Applicant: City of Albuquerque DMD Juanito SERNA		Phone: 505.218.2004
Address: One Civic Plaza		Email: JESERNA@CABQ.GOV
City: ALBUQ.	State: NM	Zip: 87102
Professional/Agent (if any): LEE GAMELSKY ARCHITECTS P.C. Att: LEE GAMELSKY		Phone: 505.842.8865
Address: 2412 Miles Rd SE		Email: lee@lganm.com
City: ALBUQ.	State: NM	Zip: 87106
Proprietary Interest in Site: ARCHITECT of Project		List all owners: City of ALBUQ.

An update of the previously approved Site Plan from DRB for Building Permit Approval - BP-2022-47072

RE: Westgate Community Center
Building Additions and Site Improvements
10001 DeVargas Road SW
Albuquerque, NM 87121

Building Permit: BP-2022-47072

SITE PLAN

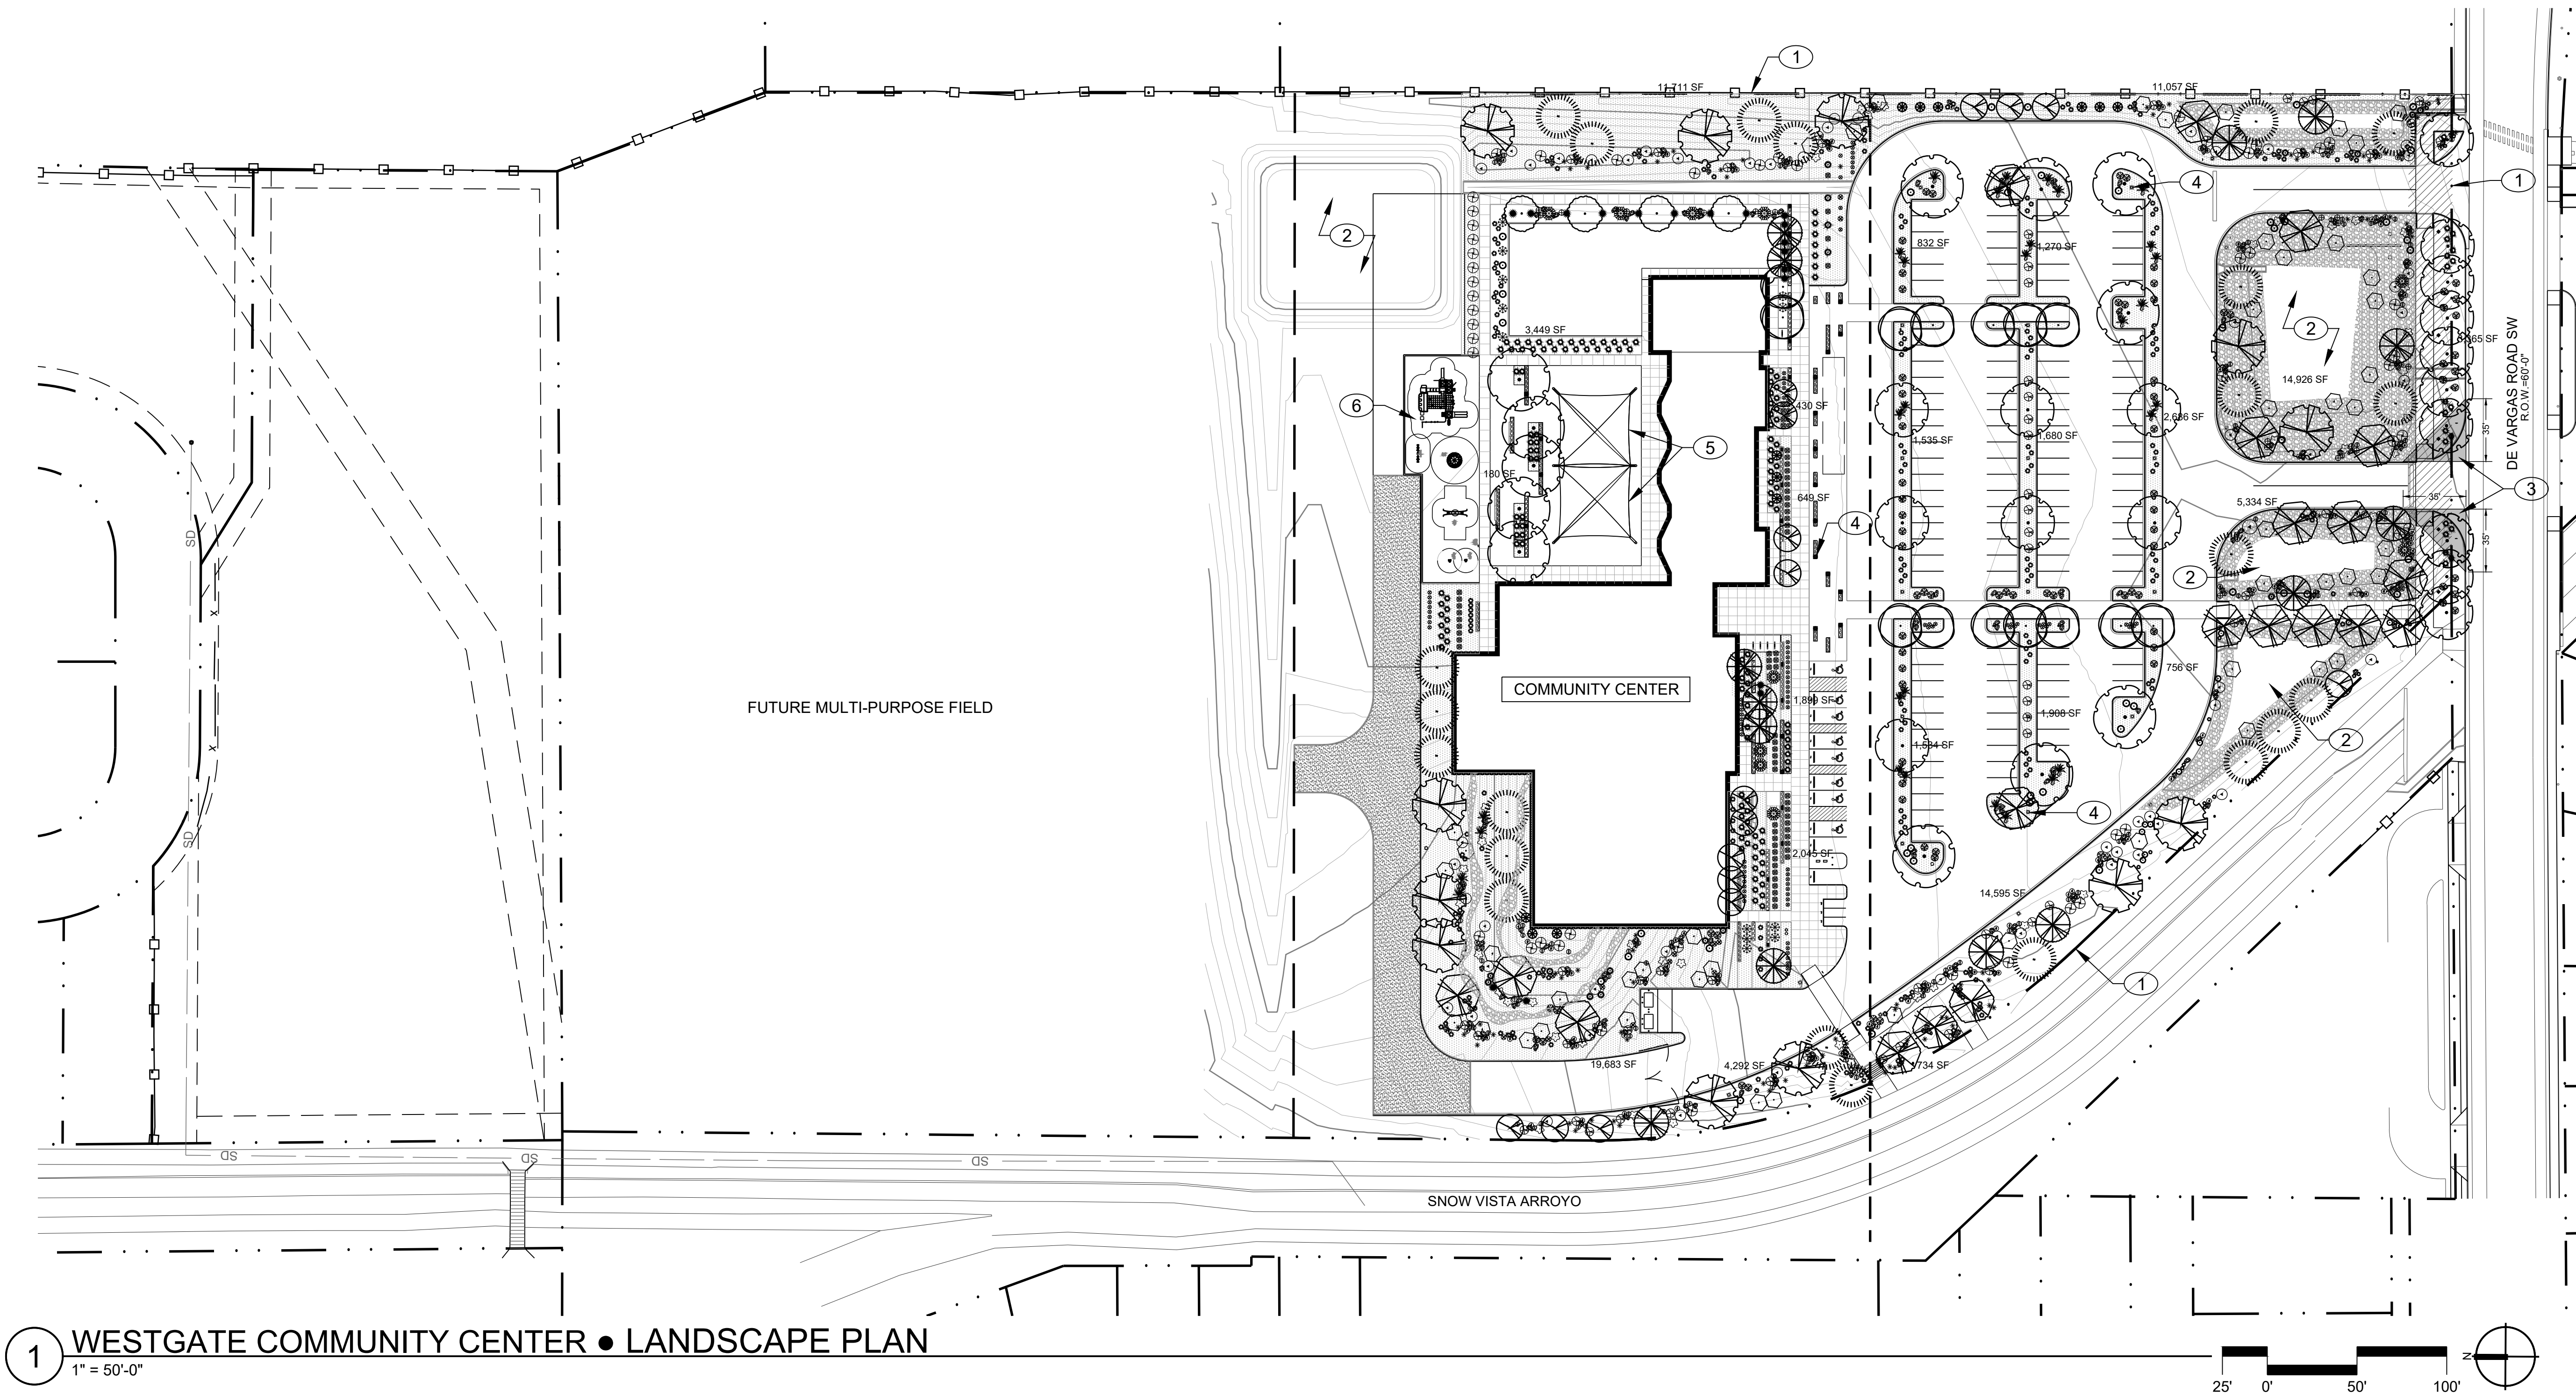
The new Site Plan differs from the previously approved Site Plan that was part of the DRB Application in the following areas:

SITE PLAN • ADMINISTRATIVE
EXTERIOR ELEVATIONS

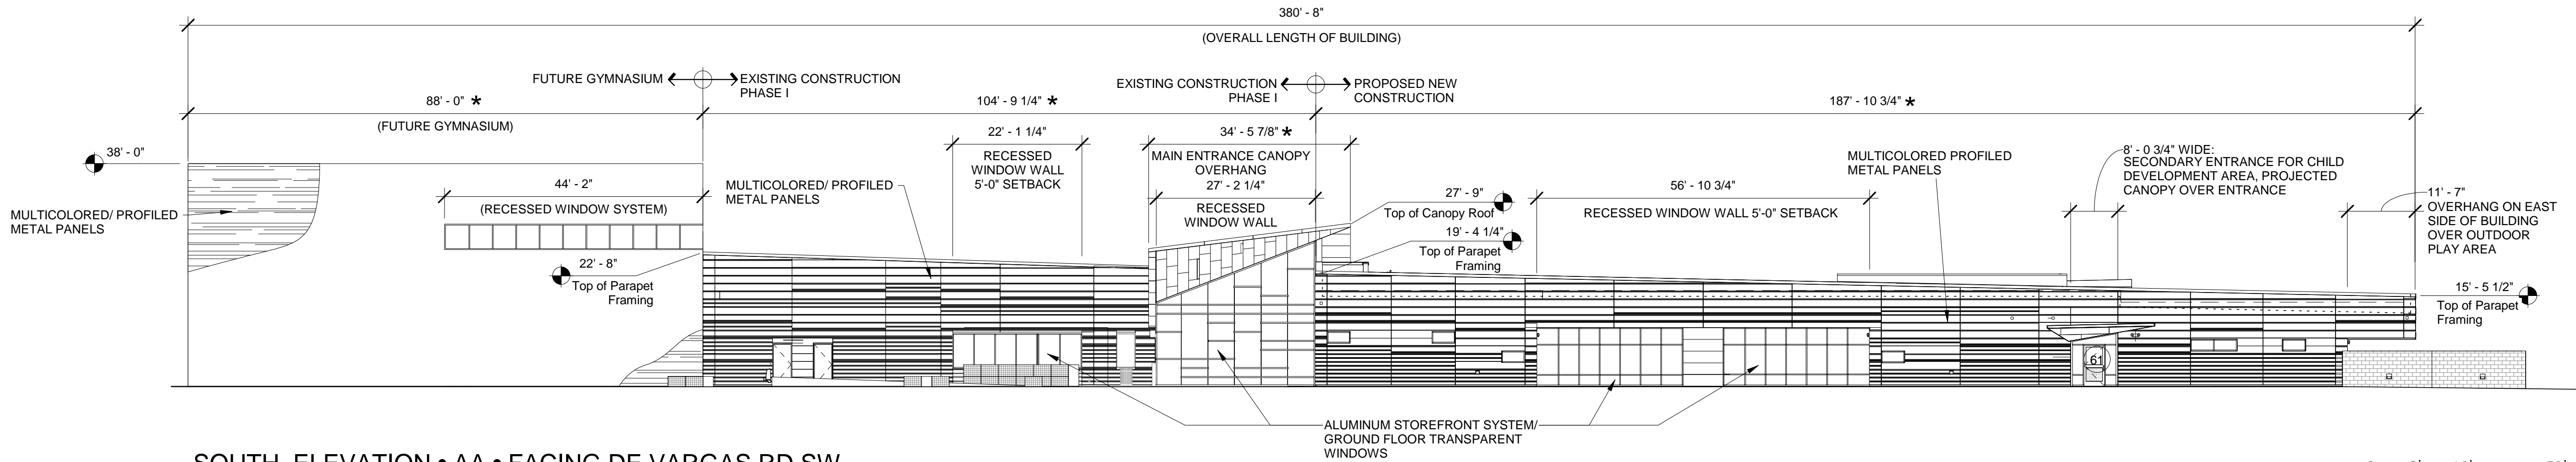
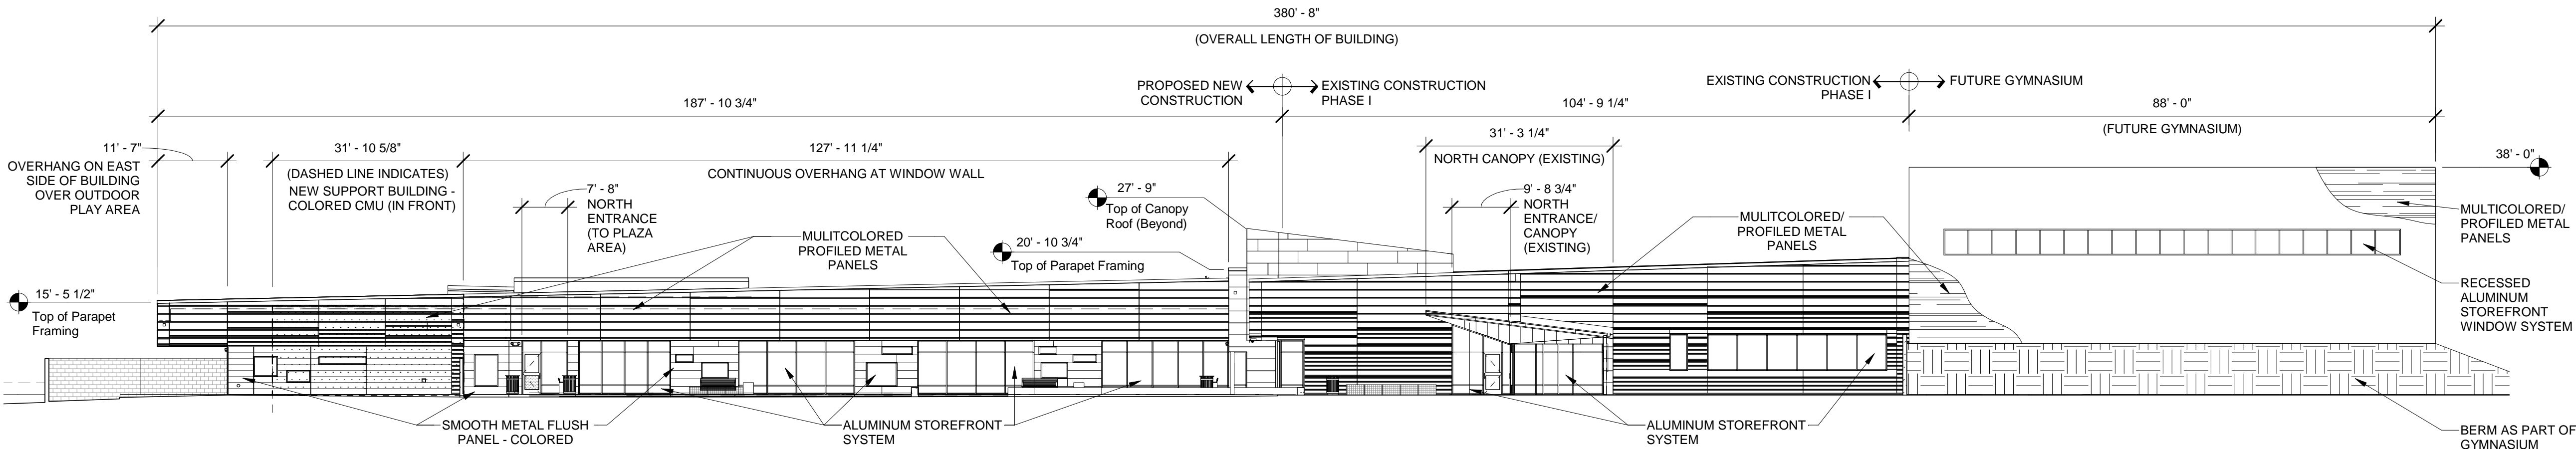
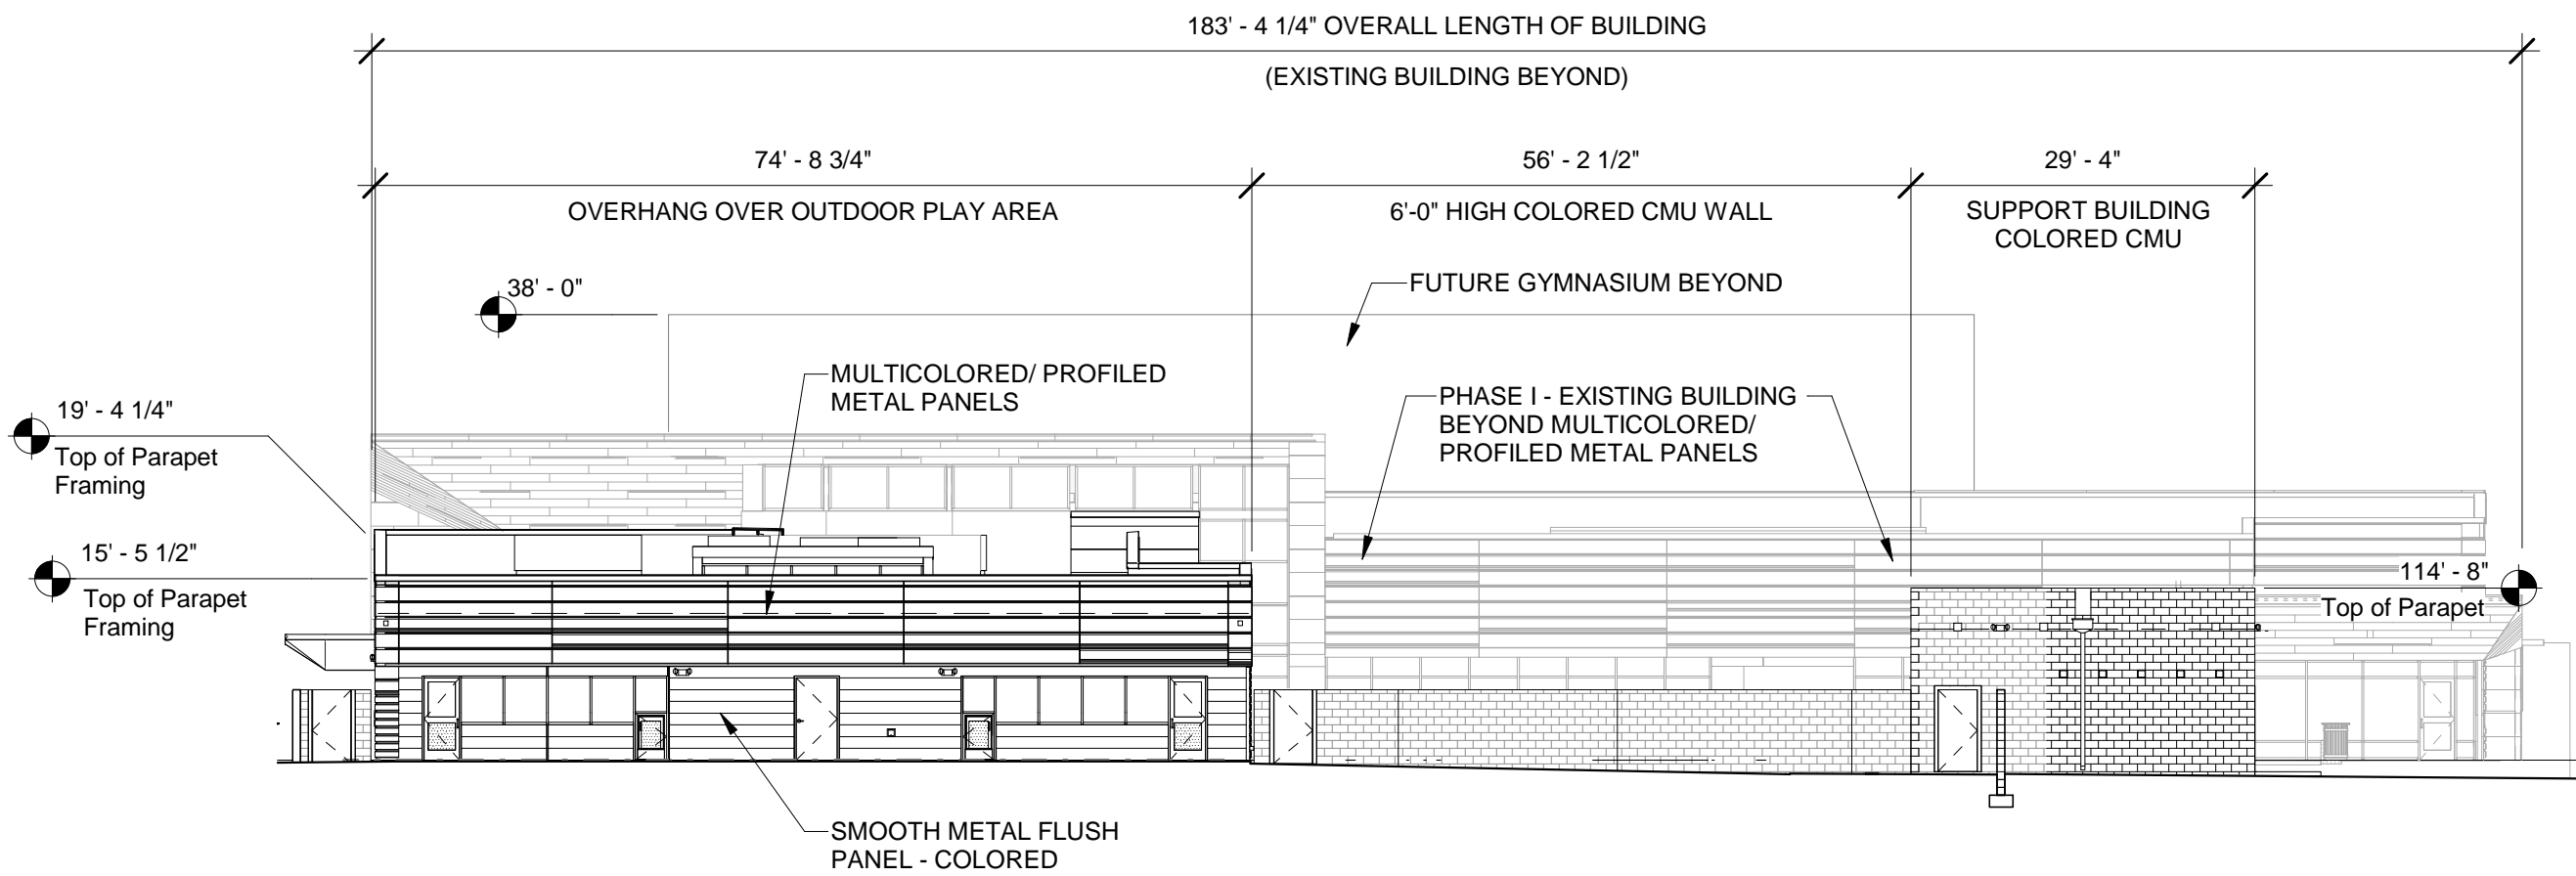
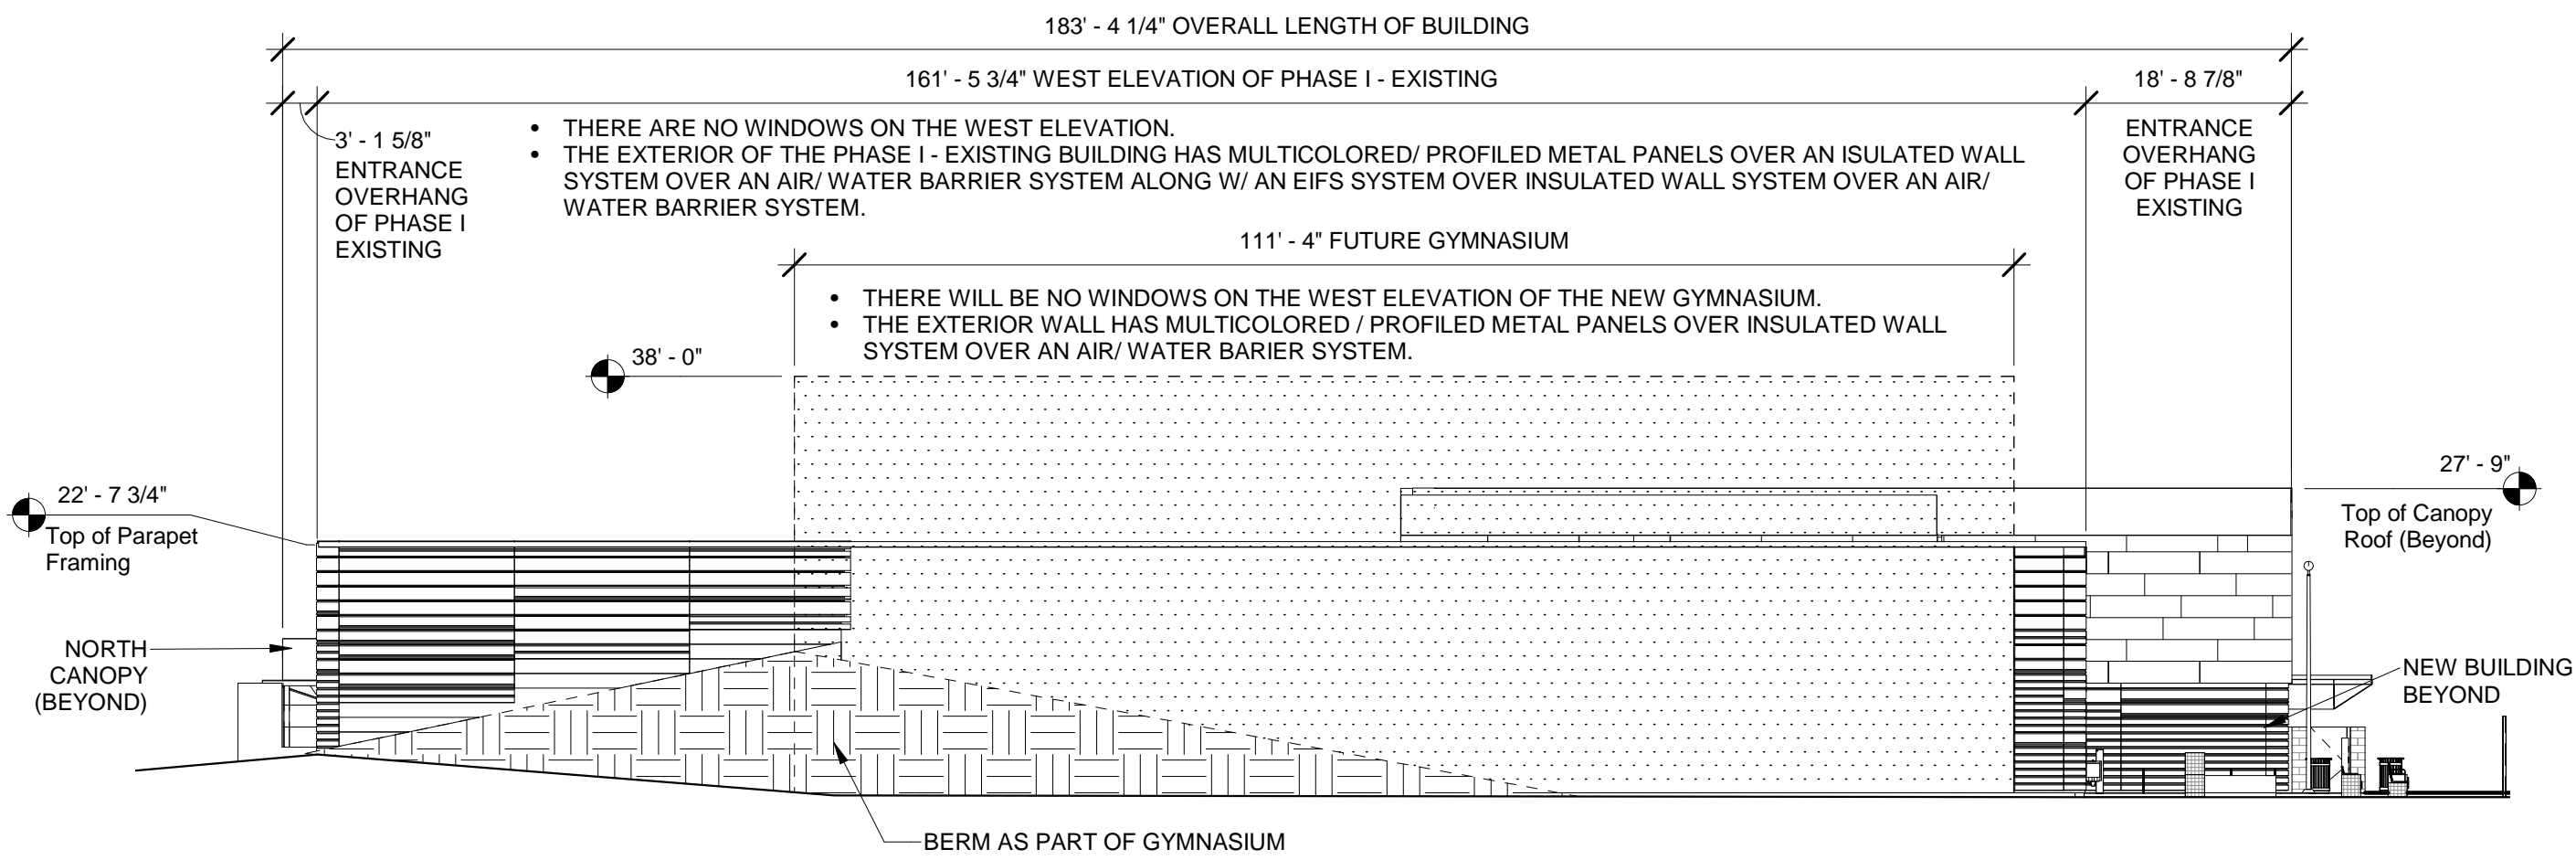
5. The total square footage of the buildings will be 37,263 GSF.

Therefore, the Total new Building Area will be 1,863 GSF greater, or 5% greater than the previously approved DRB application.

- Phase 1 (existing) is 15,750 SF vs. 15,327 in the DRB.
- Meeting room additions will be 7,900 GSF vs. 7,004 GSF in the DRB.
- Child Development Classrooms will be 2,875 GSF vs. 2,717 in the DRB.
- Gymnasium will be 9,800 GSF vs. 9,345 GSF in the DRB.
- A Support Building of 938 GSF is now indicated.
